**1958 Agreement: Consideration of draft amendments
to existing Regulations submitted by GRSP**

Proposal for Supplement 1 to the 07 series of amendments to Regulation No. 16 (Safety-belts)

Submitted by the Working Party on Passive Safety*

Figure 2

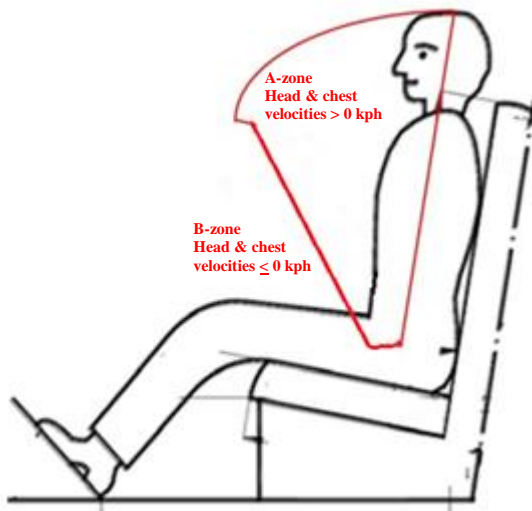
Insert a new item 12.1., to read:

- "12.1. In case a restraint system has been granted/extended approval, those can be used for particular types of vehicles compatible with the following dimensional conditions: no interior part in a quoted A-zone as shown below (Figure 2):

Figures 1 to 3, amend to read:

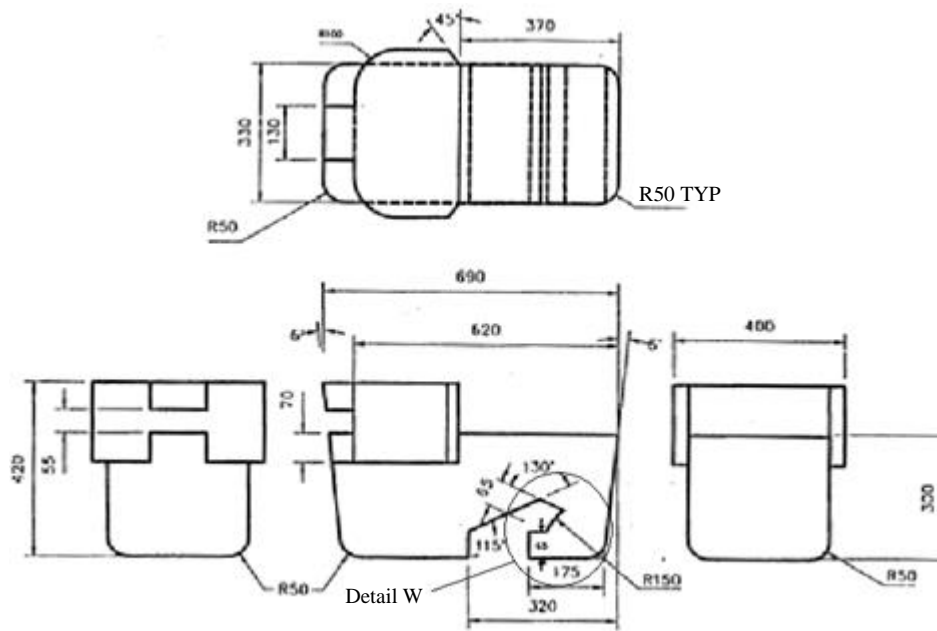
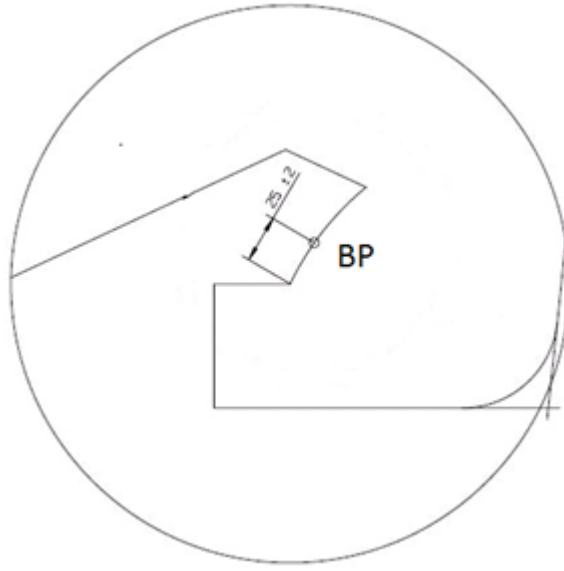
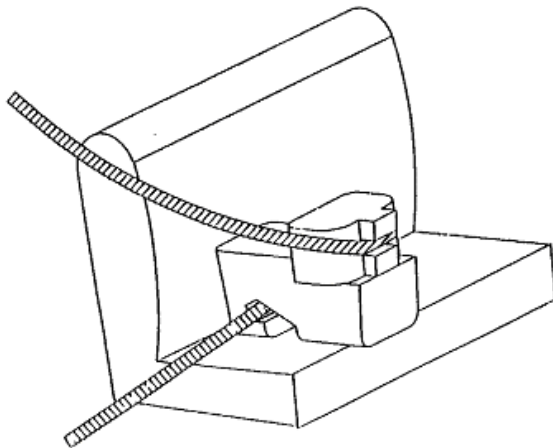
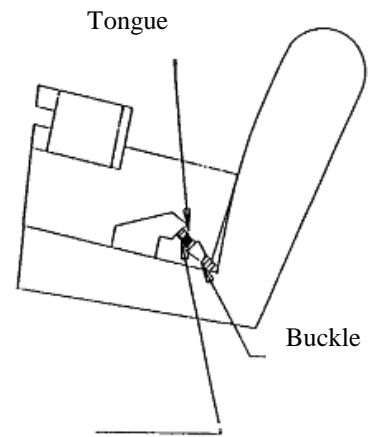
Paragraph 3.2., amend to read:

"3.2. The lap portion of the belt shall touch the fixture on both sides at the rear of the lap belt path (see Figure 3). The seat belt webbing shall always cover the points BP on the left and right ends of the curved edge; the exact position of point BP on the curved edge is indicated in detail W of Figure 1."

Figure 7
Reduced-Size Rearward Facing toddler CRS Envelope dimensions for a reduced-size rearward-facing CRS, modified for improved compatibility with the vehicle interior

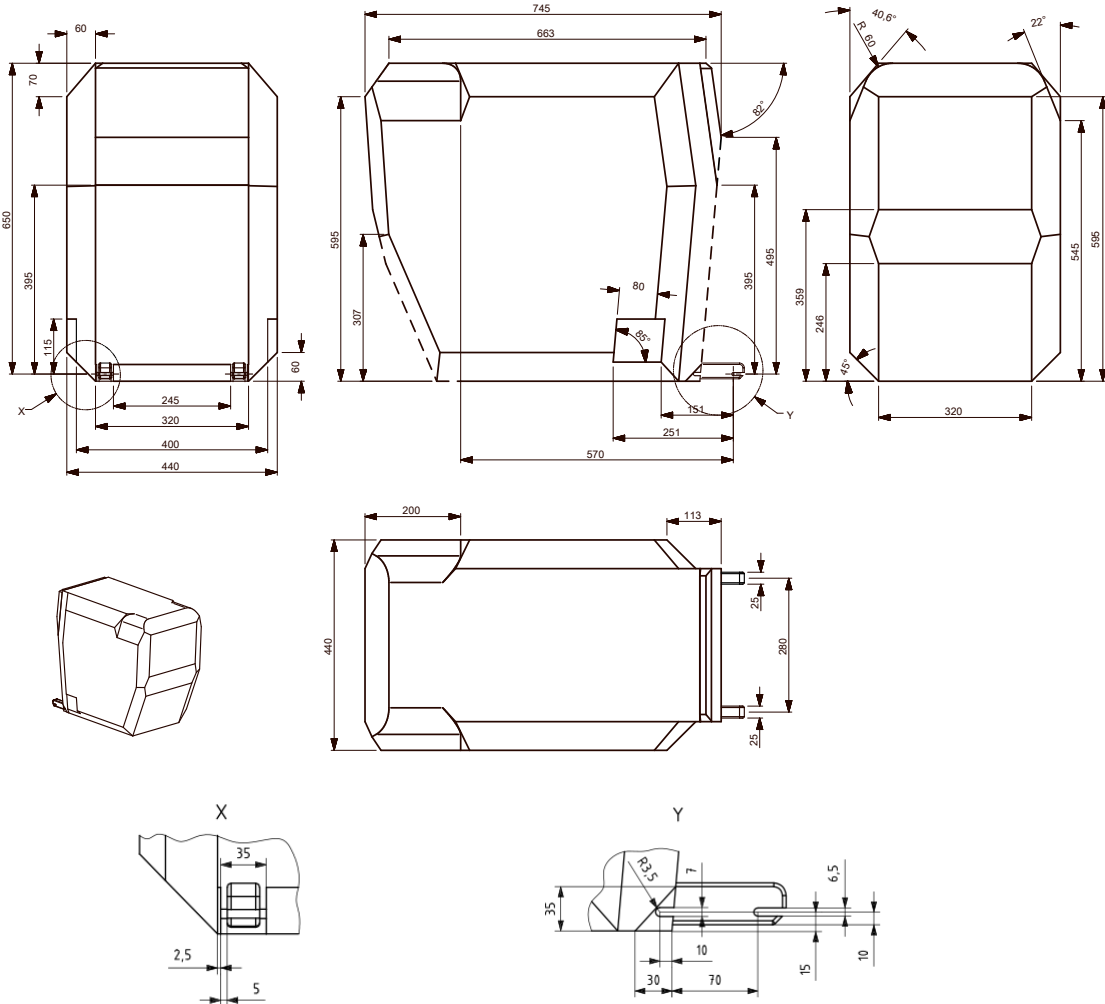
Appendix 2, insert a new paragraph 4.7. and a new Figure 7 to read:

"4.7. Rearward facing infant child restraint systems envelope ISO/R2X

Figure 8

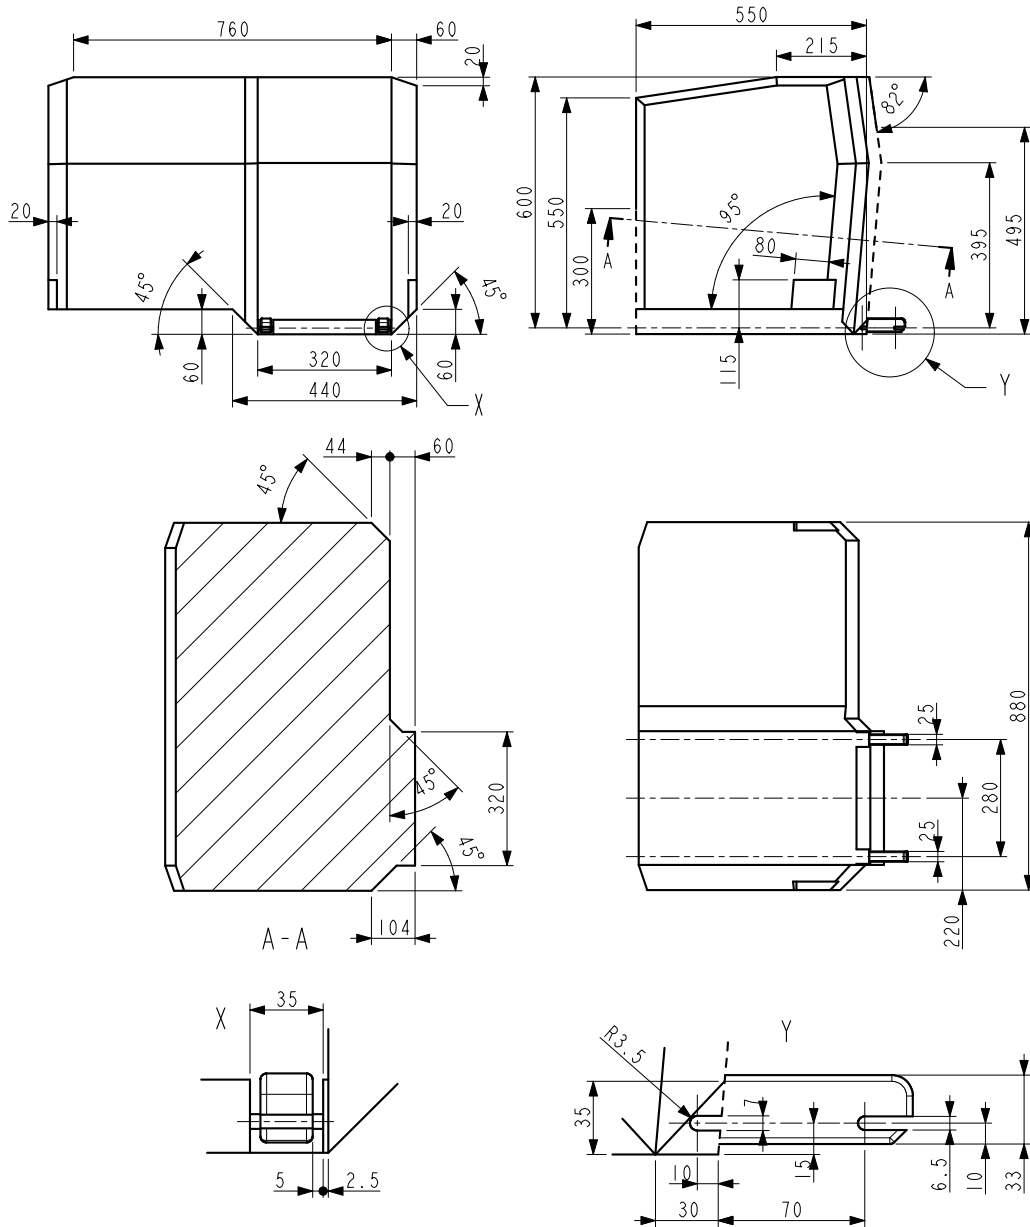
Appendix 2, paragraph 4.7 (former), renumber as paragraph 4.8. and amend to read:

"4.8. Lateral facing child restraint systems envelope

Figure 1
Positioning in Seat

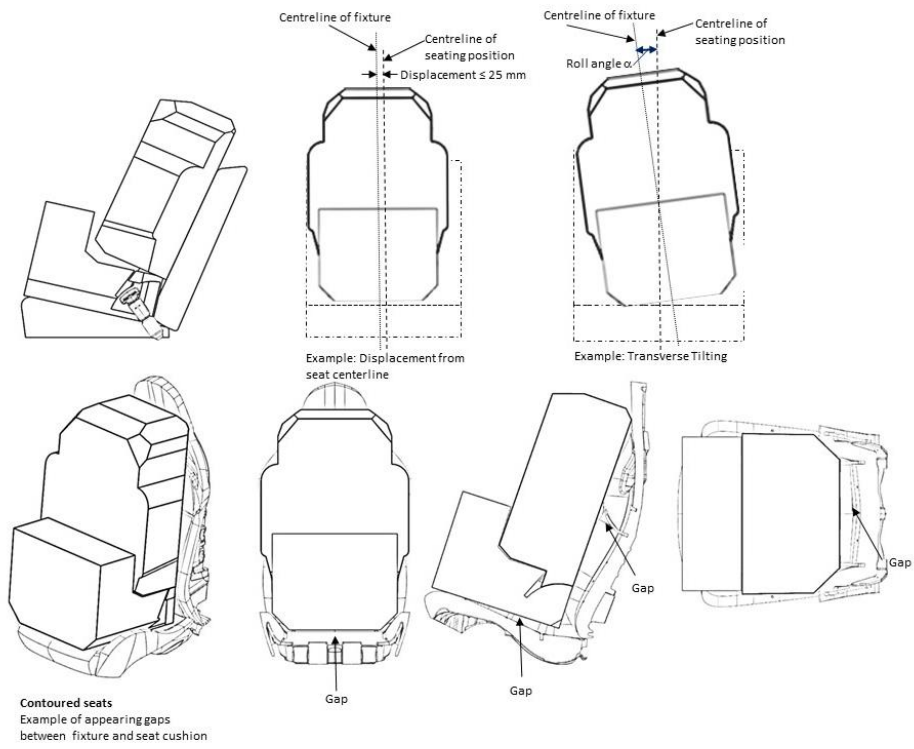
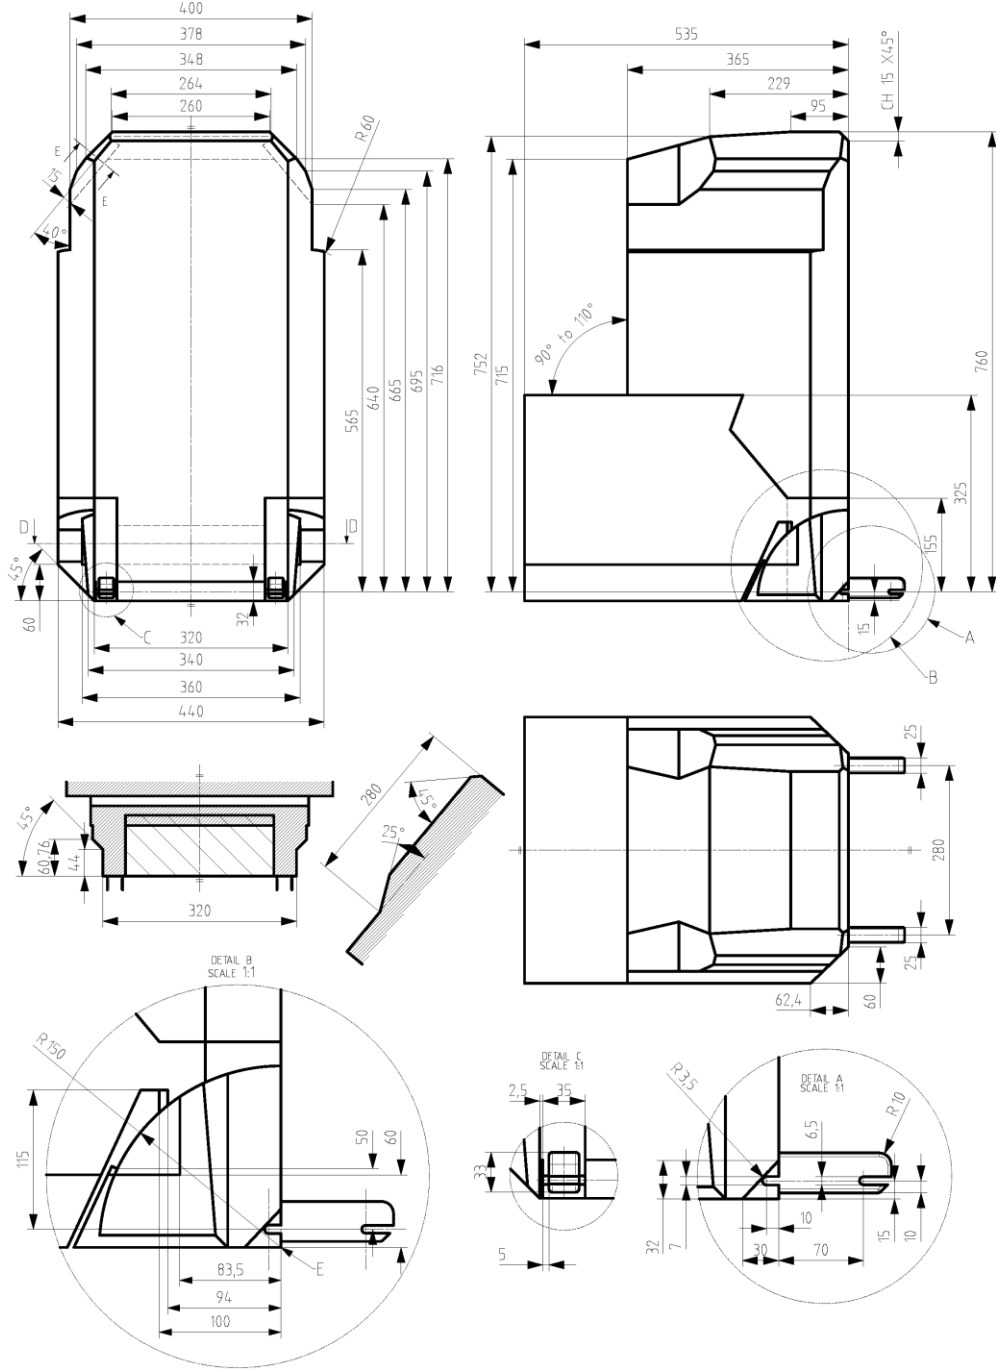
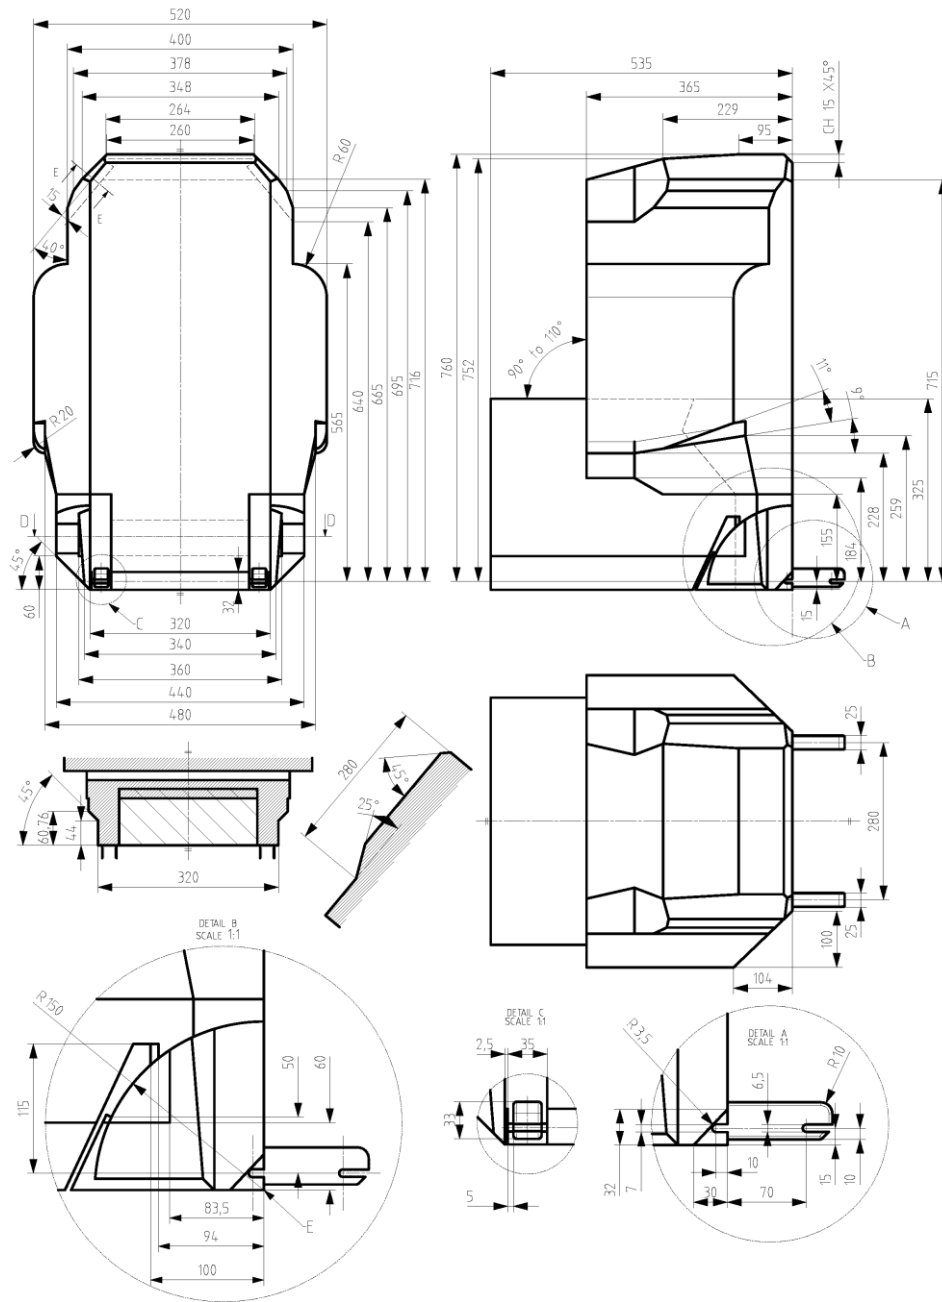
Insert a new Appendix 5 to read:

Provisions concerning the installation of forward-facing booster seat child restraint systems of universal and specific categories installed on vehicle seating positions or i-Size seating positions

4. Booster seat child restraint system fixtures:
 - (a) ISO/B2: Booster seat, reduced width 440 mm (figure 2)
 - (b) ISO/B3: booster seat, full width 520 mm (figure 3)
